Access Compliance Report

Public Rights-of-Way

Intersection ID: 10023442	Main Street: COPPER_WY	Cross Street: CHUCK_HOLLOW_LN	Location: SE
ADA ID: 818B56EB9FA1	Ramp Type: BlendTrans1	Initial Pass/Fail: Fail	Overall Compliance: No
Severity Score: 10			
Codes/Mitigation Info/Possible Solution		Field Measurements/Component Compliance

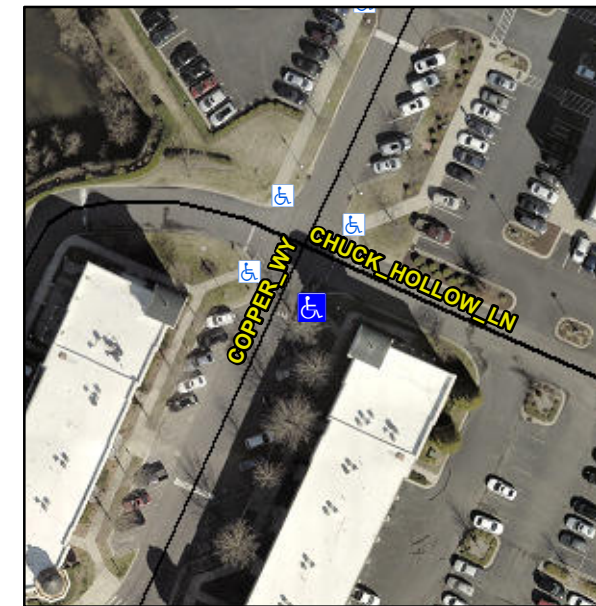
Not Found, R304.5.1, R304.5.3

Compliance	Description	Data	Compliance	Description	Data
N/A	Ramp Length (in)	67.0	Yes	BlendTrans Slope (%)	4.4
No	Ramp Width (in)	42.0	No	BlendTrans XSlope (%)	2.8
N/A	Flare Type LT	N/A	N/A	Flare Type RT	N/A
N/A	Flare Slope LT (%)	N/A	N/A	Flare Slope RT (%)	N/A
N/A	Flare Traversable LT?	N/A	N/A	Flare Traversable RT?	N/A
N/A	Landing Length (in)	N/A	N/A	DWS Provided?	N/A
N/A	Landing Width (in)	N/A	N/A	DWS Contrast?	N/A
N/A	Landing Slope (%)	N/A	N/A	DWS Length (in)	N/A
N/A	Landing X Slope (%)	N/A	N/A	DWS Full Width?	N/A
N/A	Landing Curb? (Y/N)	N/A	N/A	DWS Offset (in)	N/A
N/A	Shared Landing?	N/A			
N/A	Gutter Ponding?	N/A	N/A	Gutter Slope (%)	N/A
N/A	Gutter Lip Ht (in)	N/A	N/A	Gutter X Slope (%)	N/A
N/A	Painted X Walk1?	Yes	N/A	Painted X Walk2?	No
	X Walk 1 Direction	To NE		X Walk 2 Direction	To NW
	X Walk 1 Width (in)	52.0		X Walk 2 Width (in)	N/A
	X Walk 1 Slope (%)	0.3		X Walk 2 Slope (%)	0.5
	X Walk 1 X Slope (%)	1.3		X Walk 2 X Slope (%)	1.2

N/A	Ramp inside XWalk1?	Yes	N/A	Ramp inside XWalk2?	N/A
	Road Slope (%)	0.0		Clear Space?	N/A
	Road X Slope (%)	0.7	N/A	Clear Space to XWalk (in)	N/A
N/A	Any Obstructions?	N/A	N/A	Storm Grate/Utility Hazard?	N/A
	Obstruction Type			Storm Grate/Utility Type	
		N/A			N/A
			Yes	Surface Condition? (G/P)	Good
			No	Curb Slope (%)	11.7

Remove & Replace Curb Ramp With Two New Directional Ramps or Equivalent.
